**GENOA CHARTER TOWNSHIP
PLANNING COMMISSION PUBLIC HEARING
SEPTEMBER 14, 2020
6:30 P.M.
AGENDA**

OPEN PUBLIC HEARING # 1...Review of a special use application, environmental impact assessment and site plan for a proposed 28,851 sq. ft. addition for a retreat center which will include overnight stays located at 1391 Kellogg, southwest corner of Kellogg and McClements Roads. The request is petitioned by the Chaldean Catholic Church of the U.S.A.

Attention:	Kelly Van Marter, AICP Planning Director and Assistant Township Manager
Subject:	The Prophet Elijah Retreat Center – Special Land Use and Site Plan Review #2
Location:	1391 Kellogg Road – southwest corner of the Kellogg Road/McClements Road intersection
Zoning:	PRF Public and Recreational Facilities District

**Re: The Prophet Elijah Retreat Center
Site Plan Review No. 2**

E6 Ground Sign - Plan
A011 SCALE: 3/4" = 1'-0"

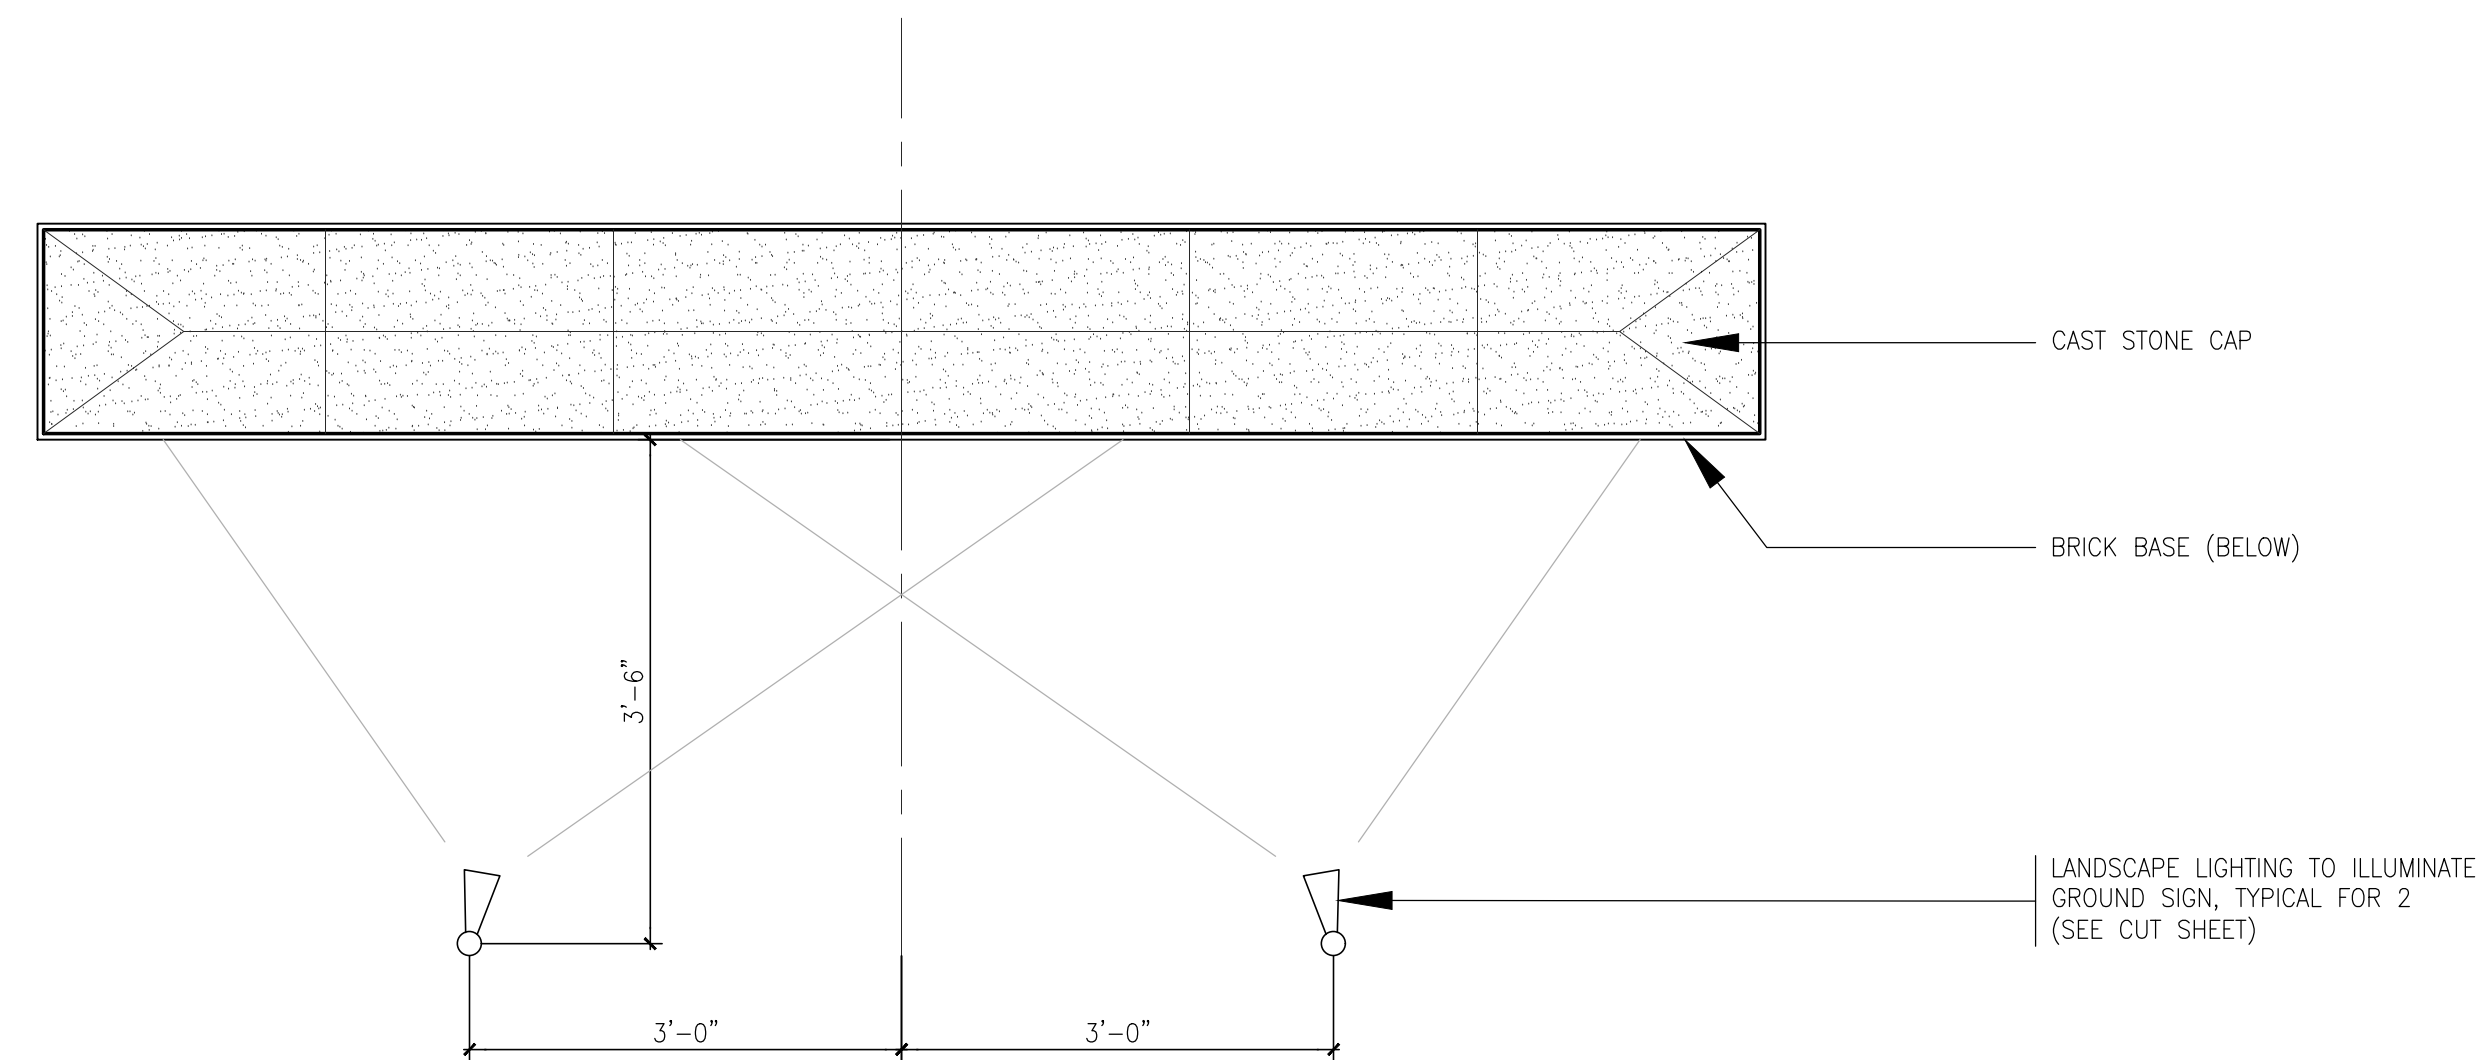
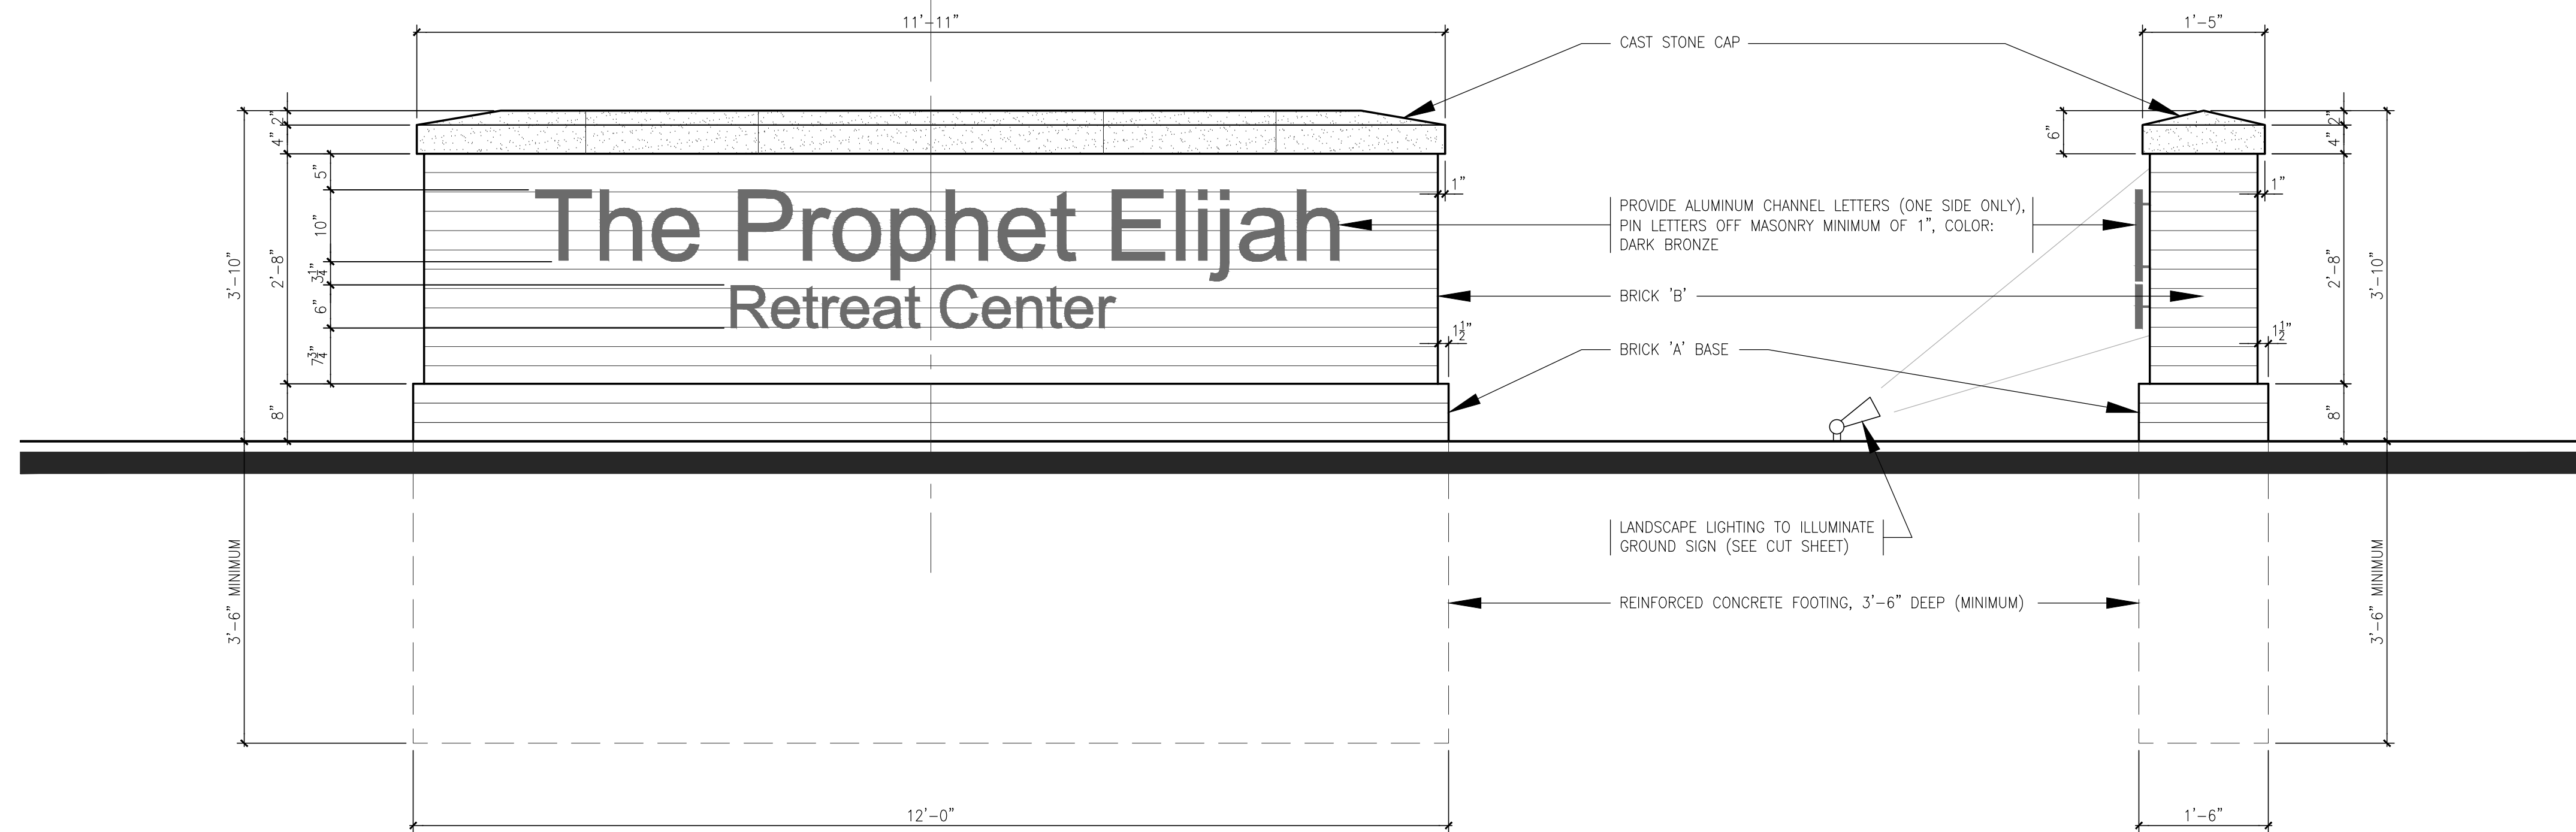
- 9. Signs.** The site plan identifies a new monument sign internal to the site (south of the proposed parking area). Details on Sheet A011 depict a masonry structure (brick and stone) with metal channel-cut lettering.

If special land use and site plan approvals are granted, the applicant must obtain a sign permit from the Township prior to installation.
